TITLE:	Security of PCB Attachment Screws
DOCUMENT NUMBER:	SB AD32/AC32-03
EQUIPMENT:	AD32 RVSM Air Data Display and AC32 Digital Air Data Computer
© Copyright by THOMMEN AIRCRAFT EQUIPMENT AG, CH-4132 Muttenz, Switzerland

SERVICE BULLETIN

Figure 1 - AD32/AC32 Casing and PCB Attachment Screws

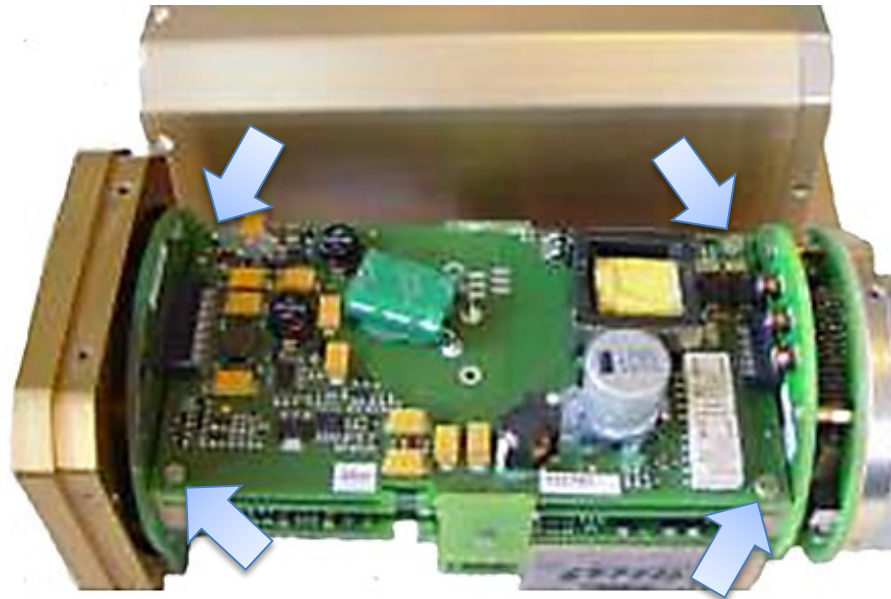
A loose object noise was heard from inside an AD/AC32 during the installation in an aircraft. The AD/AC32 was opened, and a nut and screw were found detached. This screw and nut is one of four that attach the printed circuit boards (PCBs) to the AD/AC32 internal structure.

A loose nut/screw could cause a short circuit on one of the PCBs, which could make the AD/AC32 inoperative.

This Service Bulletin (SB) gives the procedure for the application of Loctite 243 to the four screws that attach the PCB to the structure of the AD/AC32.

- (3) Remove and reinstall the four PCB attaching screws (one at a time) according to the following procedure (ref. Figure 1 and CMM):
 - Remove one of the four nuts and screws.

- Apply Loctite 243 to the threads of the screw.
 - Install the screw and the nut and tighten it to the standard torque load.
 - Apply Enictol safety lacquer on the top of the nut and screw.

- Do the procedure again for the other three positions.
- (4) For the AC32 – apply Loctite 243 on the threads of the twelve casing screws.
- (5) For the AD32 – apply Loctite 243 on the threads of the four rear casing screws.
